[Docket No. FAA–2025–5394; Project Identifier AD–2025–01194–R]

Airworthiness Directives; Restricted Category Model CH–47D Helicopters

ACTION: Supplemental notice of proposed rulemaking (SNPRM).

Figure 1 to Paragraph (g)(1)—Transmission Support Beam Inspection

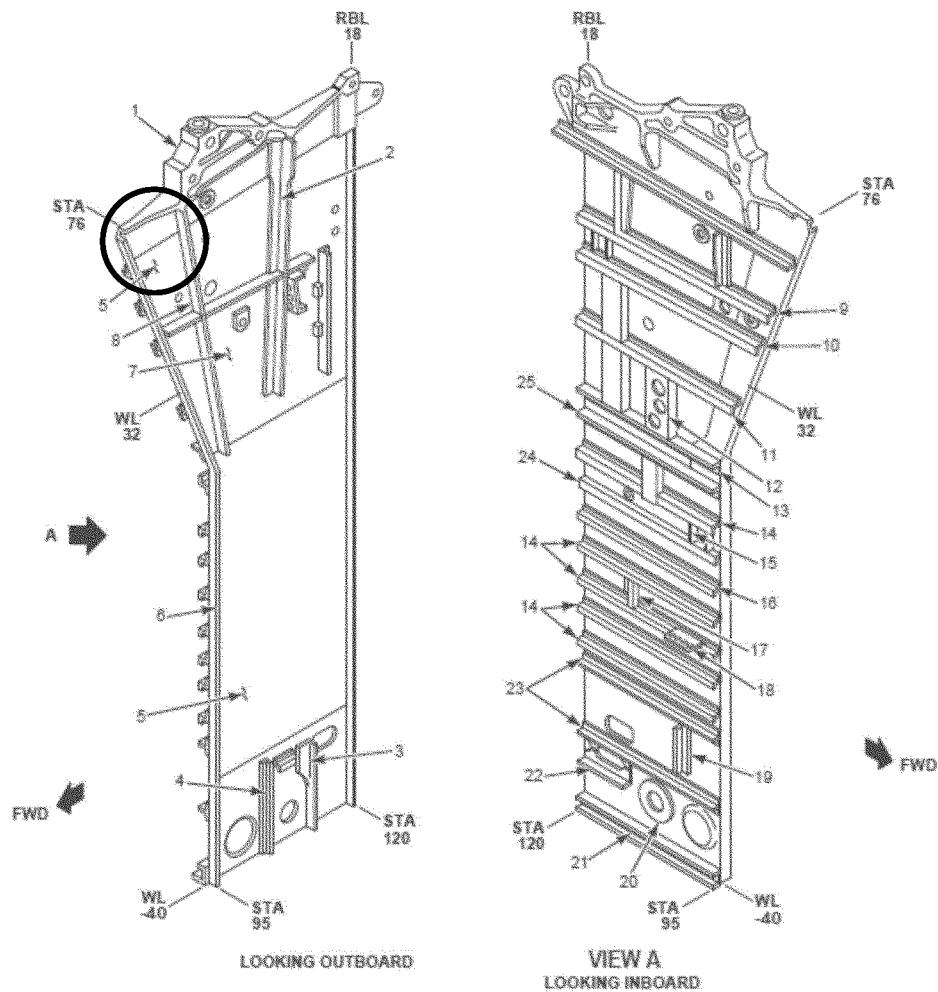
Billings Flying Service stated that if the reported cracks are exclusively found to be in the forward area on the inboard face of the mount ("area of interest"), then the inspection should be conducted and specified where the damage has been found. The commenter further stated requiring full open-up and complete mount inspection every 100 hours TIS would be a significant burden to the operator, and complete access to the installed part would require significant additional maintenance.

The FAA acknowledges the commenter's concern and infers that the commenter is requesting that the inspection area be clarified. The FAA agrees to clarify the inspection area in

order to provide a boundary area. Paragraph (g)(1) of the Required Actions paragraph of this proposed AD has been revised by adding, “and from the top cap to lower termination of the fitting for cracks” when describing the area of inspection.

(1) Within 30 hours time in service (TIS) after the effective date of this AD and thereafter at intervals not to exceed 100 hours TIS, using a 7X or higher power magnification and light source, visually inspect the RH forward transmission support beam fitting, any part number, at right butt line (RBL) 18 from station (STA) 76 to STA 95, and from the top cap to lower termination of the fitting for cracks. Fastener holes in the area circled in figure 1 to paragraph (g)(1) of this AD are most susceptible to cracking. If any crack is detected, before further flight, repair or replace parts using a method approved by the Manager, West Certification Branch, FAA, in accordance with the procedures specified in paragraph (i) of this AD.
